Nomad SERVICE BULLETIN

REDESIGNED CABLE CLAMPS FOR AUTOPILOT SYSTEMS (MODIFICATION N554)

Figure 1 MOD N554-Installation

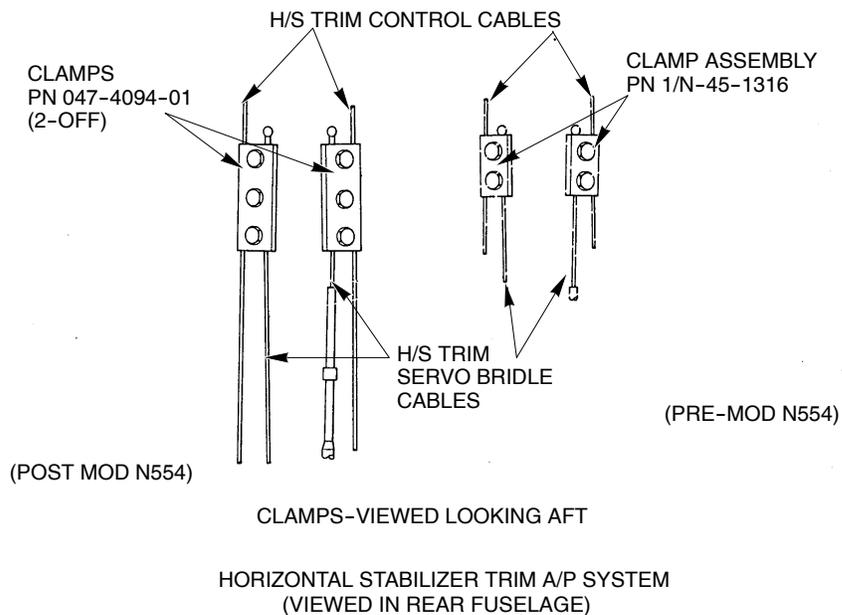
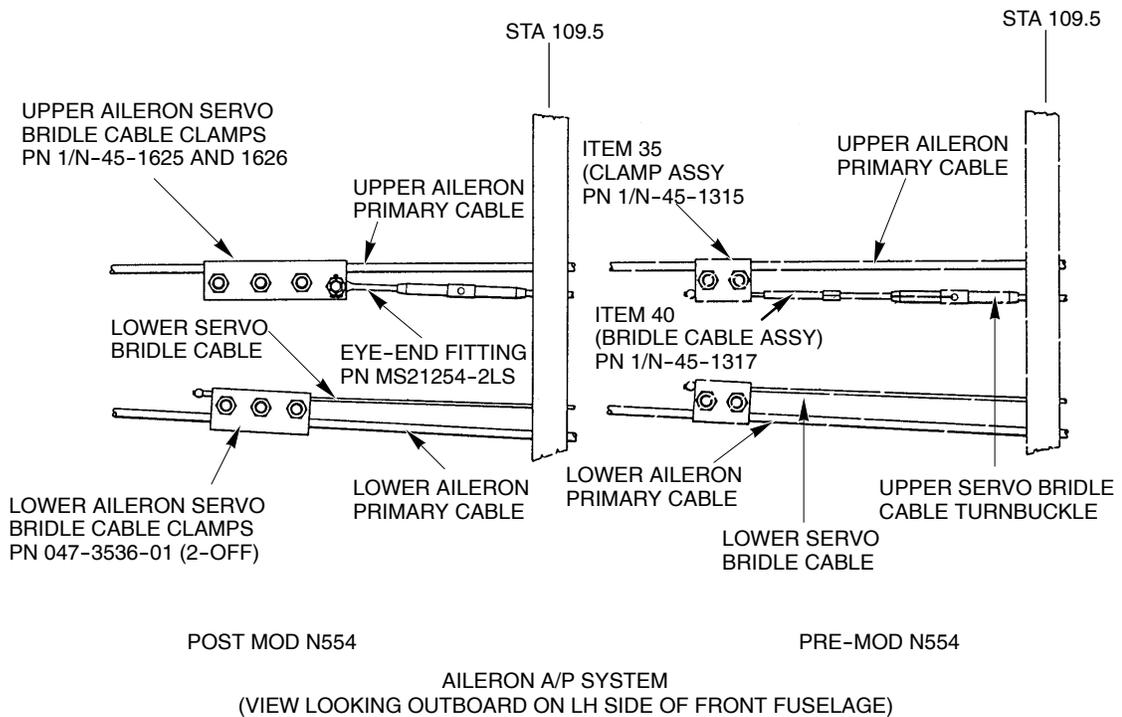
The cable clamp assemblies which secure the autopilot bridle cables to the primary control cables of the aileron control system and to the control cables of the horizontal stabilizer trim tab system are replaced by more efficient type clamps. The cable assembly, between the clamp and the turnbuckle of the aileron autopilot bridle cable, is replaced by an eye-end fitting.

A. Aileron autopilot servo system (Ref Figure 1)

B. Horizontal stabilizer trim autopilot system (Ref Figure 1)

- (1) Replace the bridle cable clamp assemblies PN 1/N-45-1315 and cable assembly 1/N-45-1317 (Ref Customer Option G48 or G48-24 Supplement IPC Section Figure 1 Sheet 2, (items (35)) and 40).

- (1) Replace the horizontal stabilizer trim autopilot servo bridle cable clamps PN 1/N-45-1316 (Ref Customer Option G48 or G48 -24 Supplement, IPC Section Figure 1 Sheet 2, item (-65)).
 - (a) Set the horizontal stabilizer trim control wheel to zero and remove the engine control box console (Ref MM 76-10-00). Install rigging pin PN 1/N-88-60 in the horizontal stabilizer trim indicator drum (Ref MM 27-41-00 Figure 201).
 - (b) Support the rear fuselage as detailed in MM Chap 7-00-00.
 - (c) Gain access to the horizontal stabilizer trim autopilot servo bridle cables (Ref Customer Option G48 or G48-24 Supplement IPC Section Figure 1 Sheets 1 and 2, items (78) and (80)). Temporarily tie the bridle cables (below the cable clamps) to the trim control cables: slacken the bridle cables by adjusting the turnbuckle, then remove the cable clamp
